RN SERIES TECHNICAL BULLETIN

ISSUE NO. : RNT-018

SUBJECT: 021-11211-208 Front Cover
021-11276-008 Front Cover SW Actuator

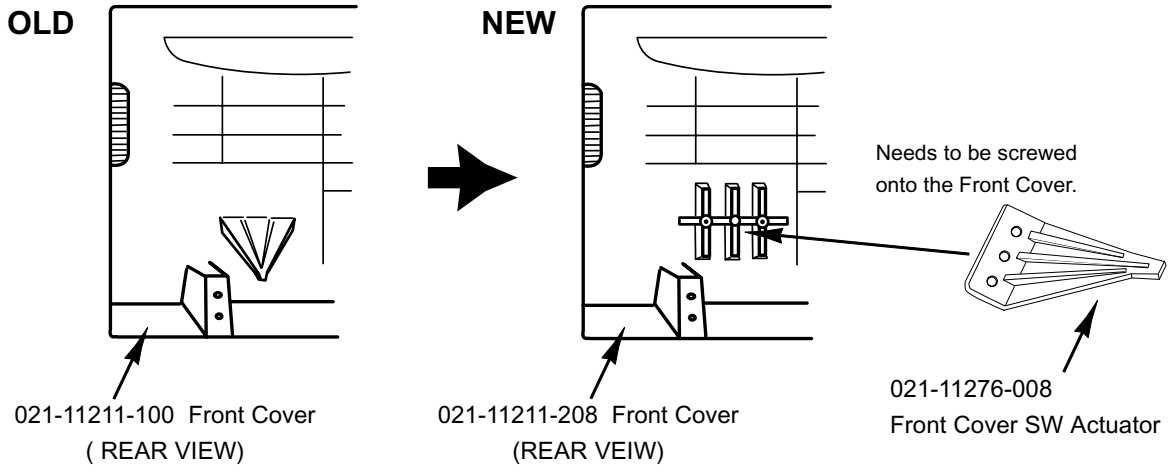
Brief:
The projected portion on the inside surface of the Front Cover, which acts as an actuator for the front cover switch, is now detachable from the Front Cover.

Reason:
If the projected portion acting as switch actuator cracks off, the whole Front Cover had to be replaced.

Modification:
The Front Cover is redesigned so that when the switch actuator breaks, the whole Front Cover need not be replaced, but only the actuator portion needs to be replaced. The newly registered Front Cover SW Actuator does not fit onto the old type Front Cover.

NOTE:
Of the three holes on the Front Cover SW Actuator, the center hole is for the positioning pin on the Front Cover, and the two holes on the sides are for screws.
Two (2) pieces of M3x10 tapping screws are required.
